April 18, 2025

River Valley School District – Roof Replacement, Door Replacement, and Restroom Renovation 15480 Three Oaks Road Three Oaks, MI 49128

This Addendum consists of Pages ADD 1-3 and Wightman Addendum No. 01 April 17, 2025, Consisting of 16 pages.

1. Sheet A600

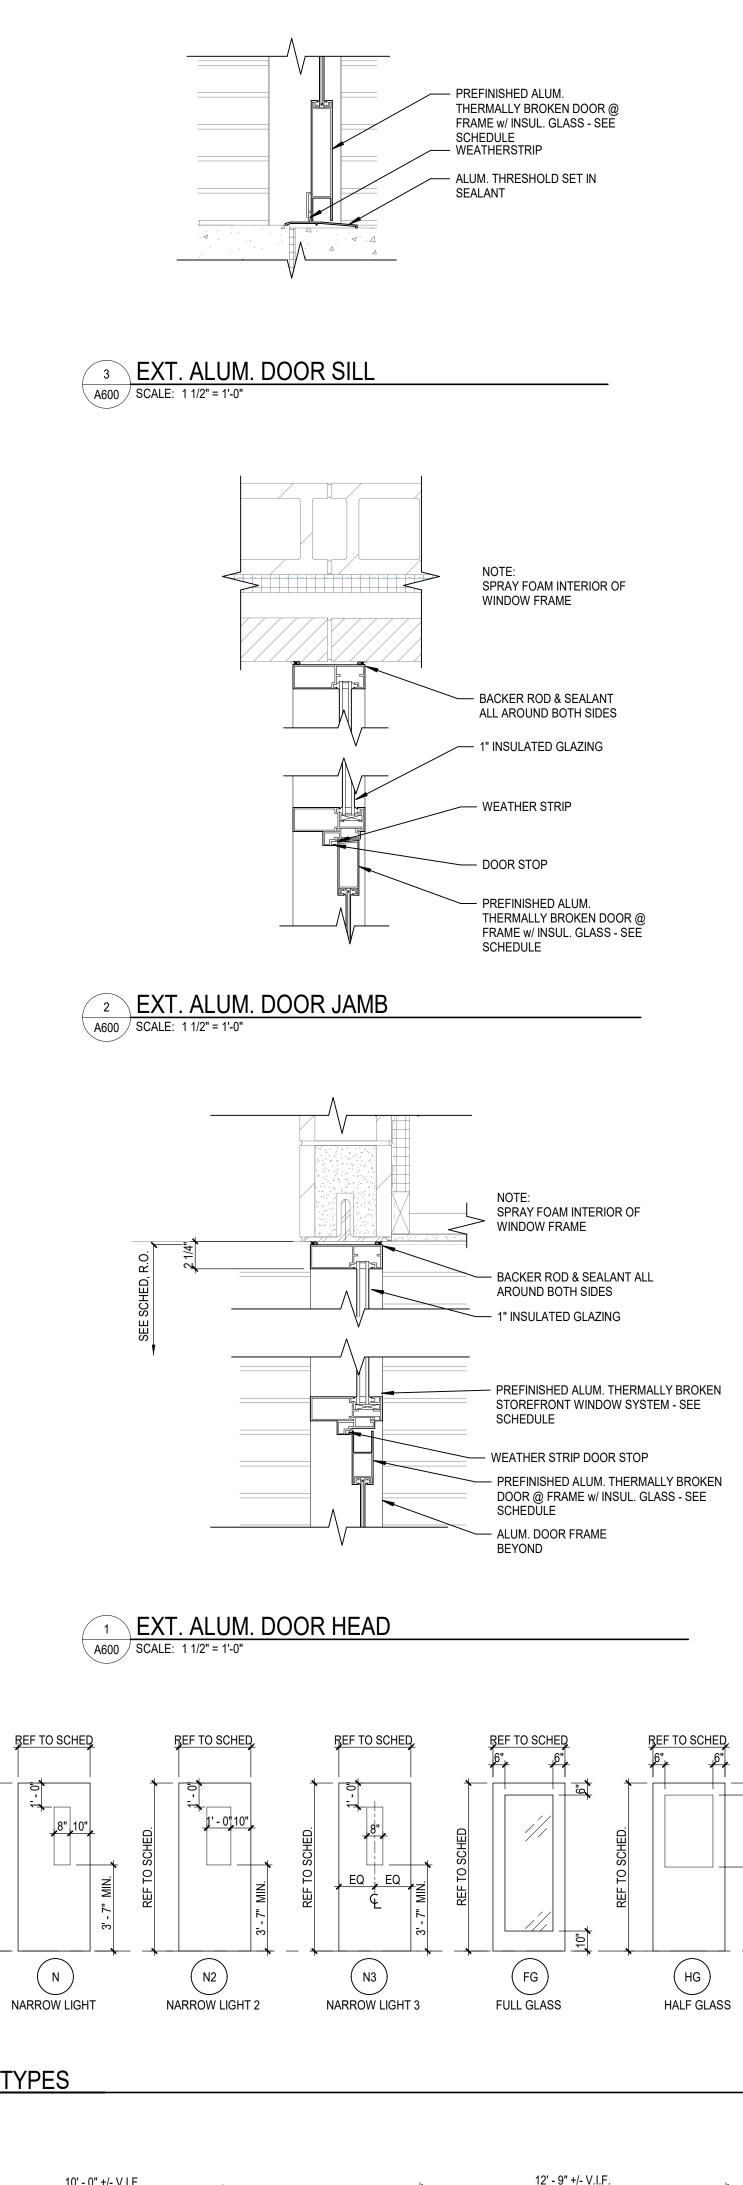
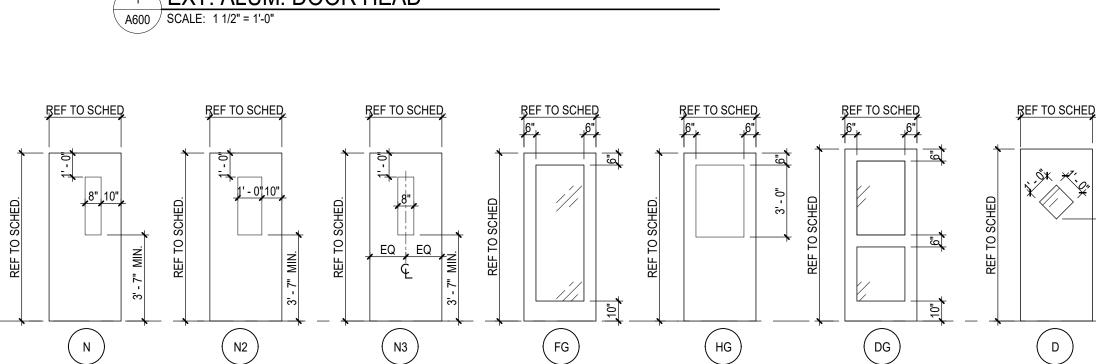
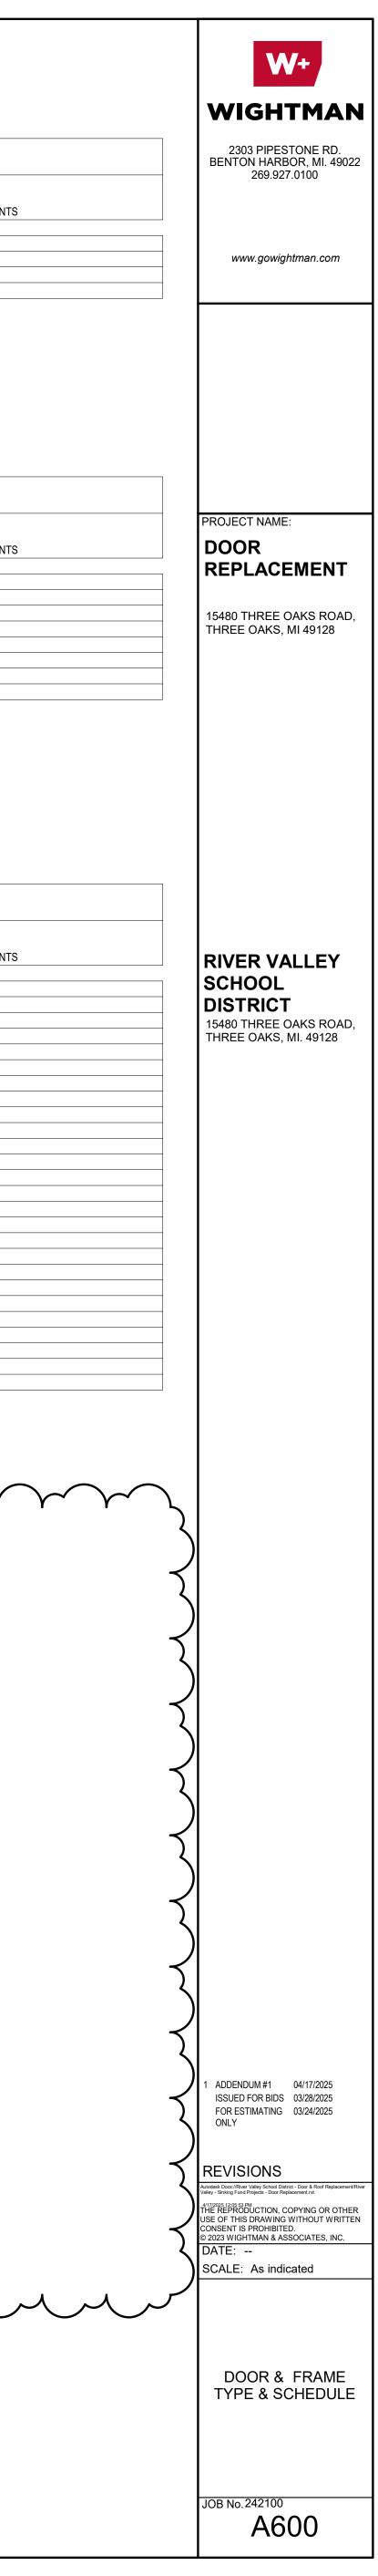
- 1. Sheet A600 (re-issued)
 - A. Alternate 4 Door Schedule has been deleted.

1. Sheet A101

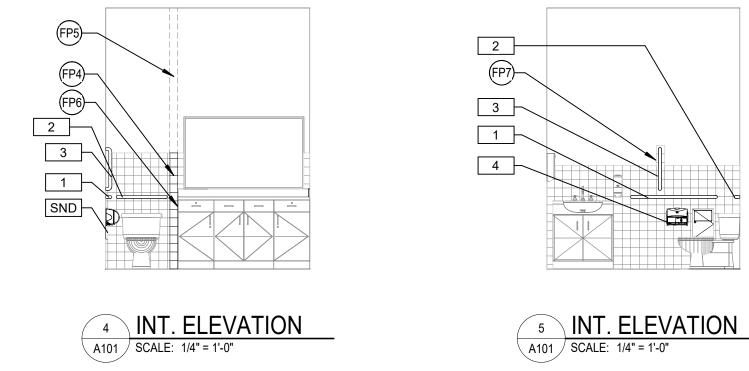
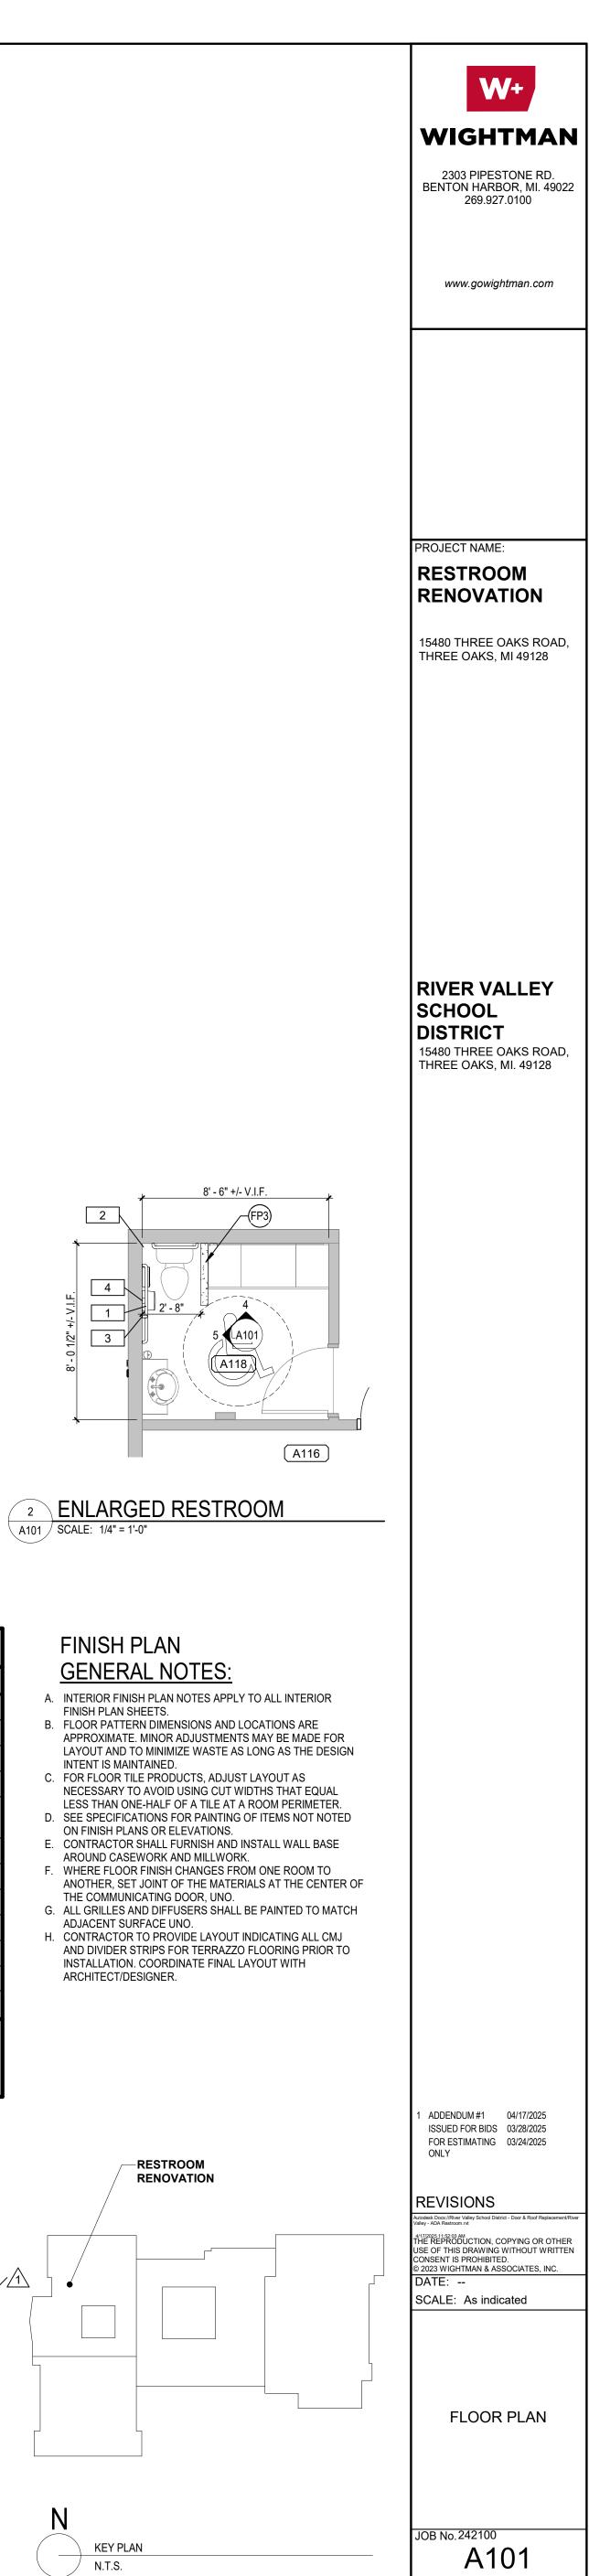
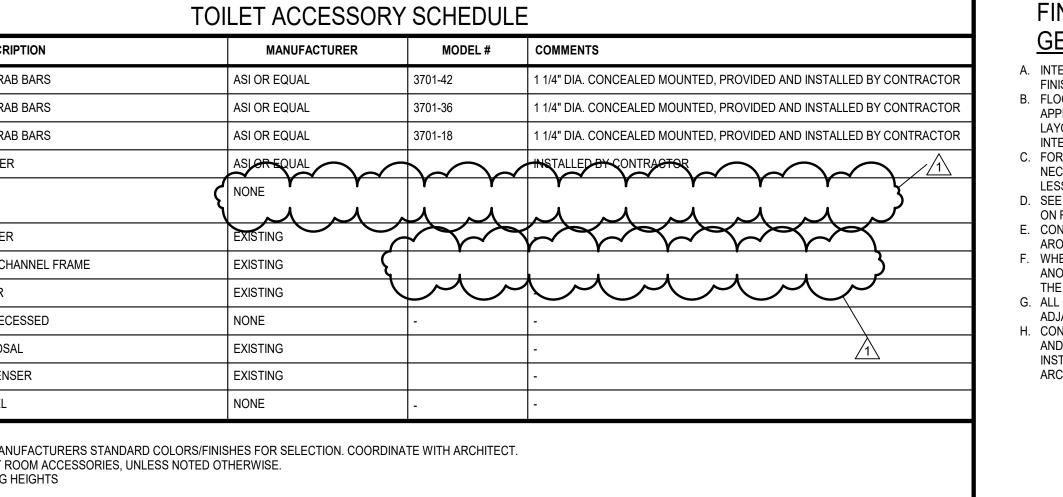
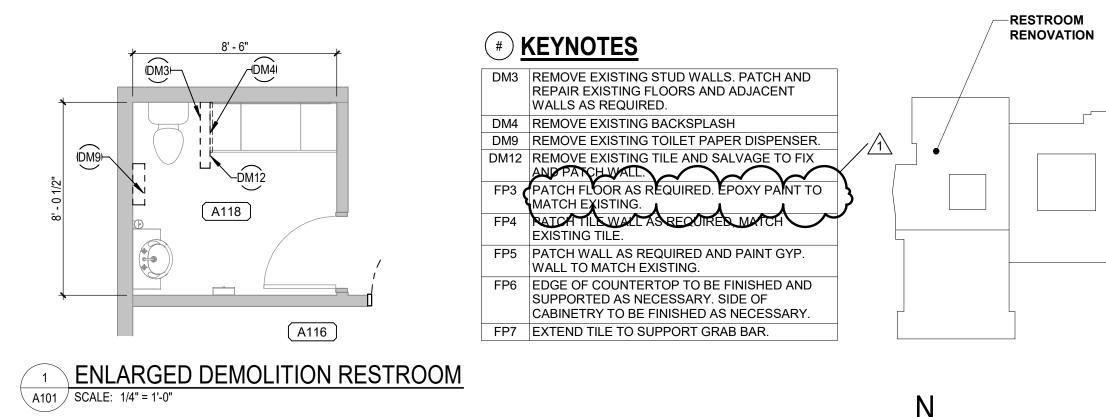
- 1. Sheet A101 (re-issued)
 - A. Toilet Accessory Schedule Mark 5 has been revised
 - B. Toilet Accessory Schedule Mark 7 has been revised
 - C. Keynotes FP3 has been revised

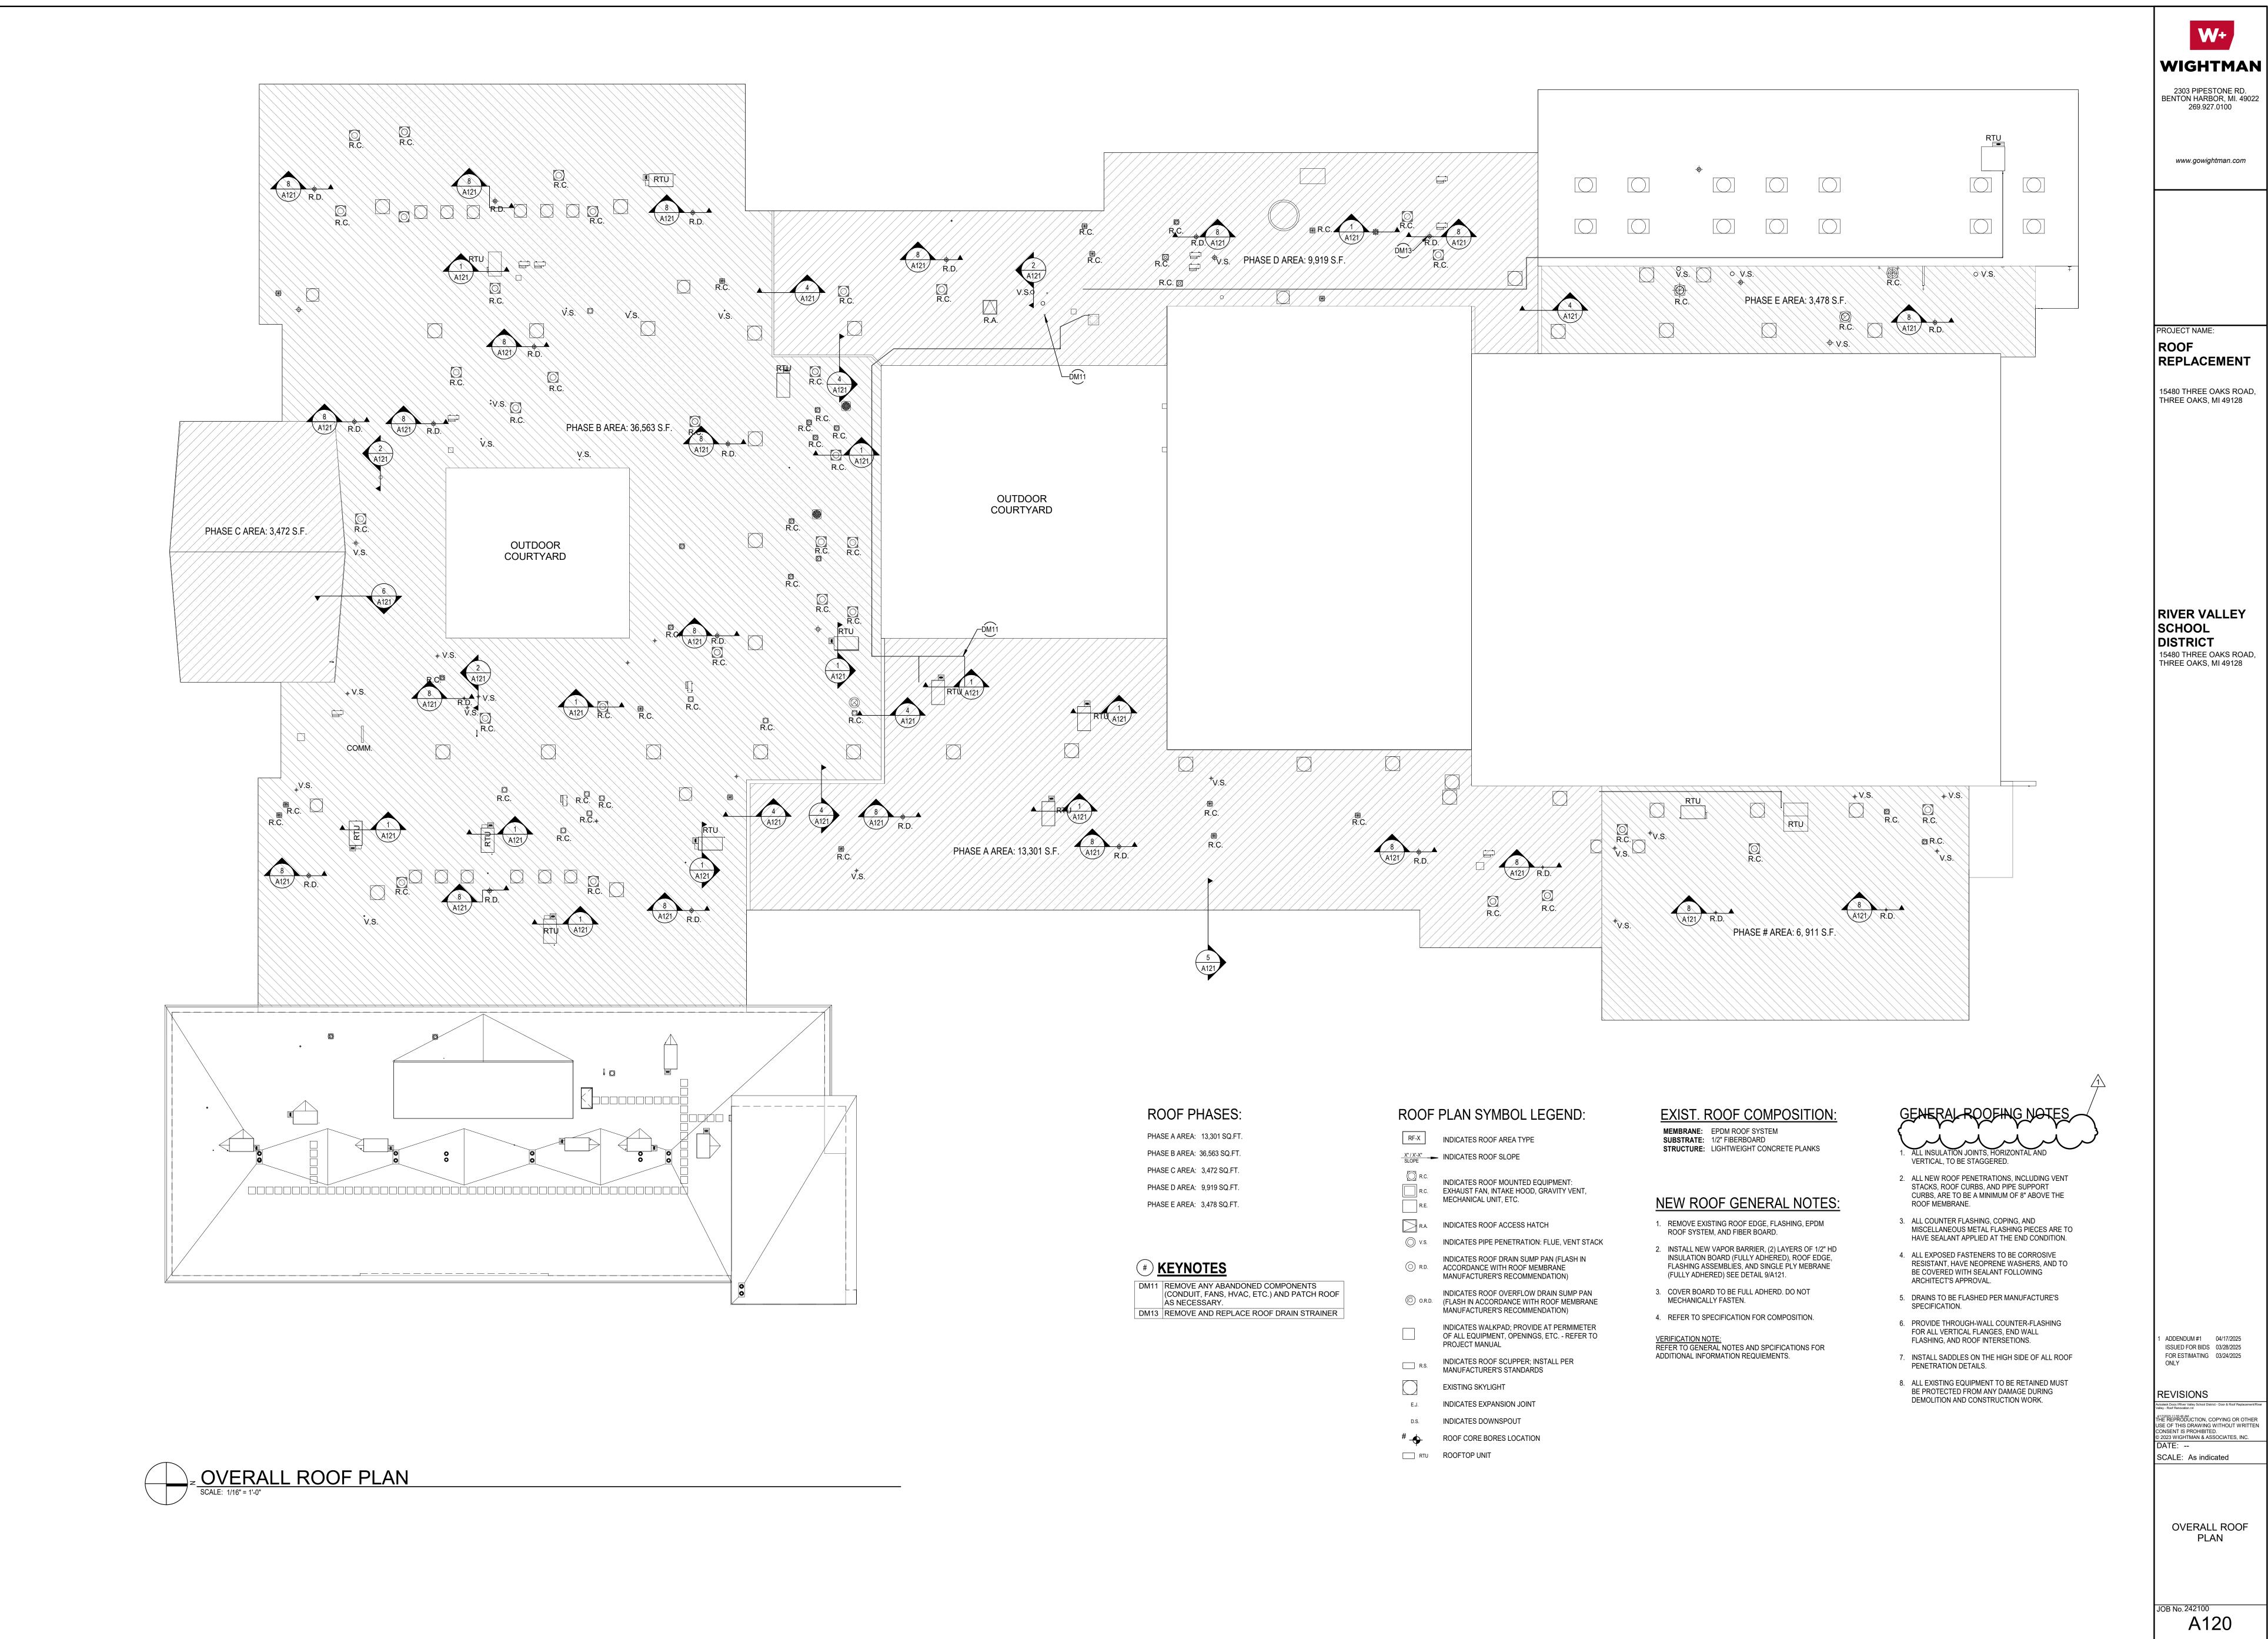
- 1. Sheet A120 (re-issued)
 - A. General Roofing Notes Reference to taper insulation has been deleted.
- 2. Sheet A121 (re-issued)
 - A. All details have been revised.
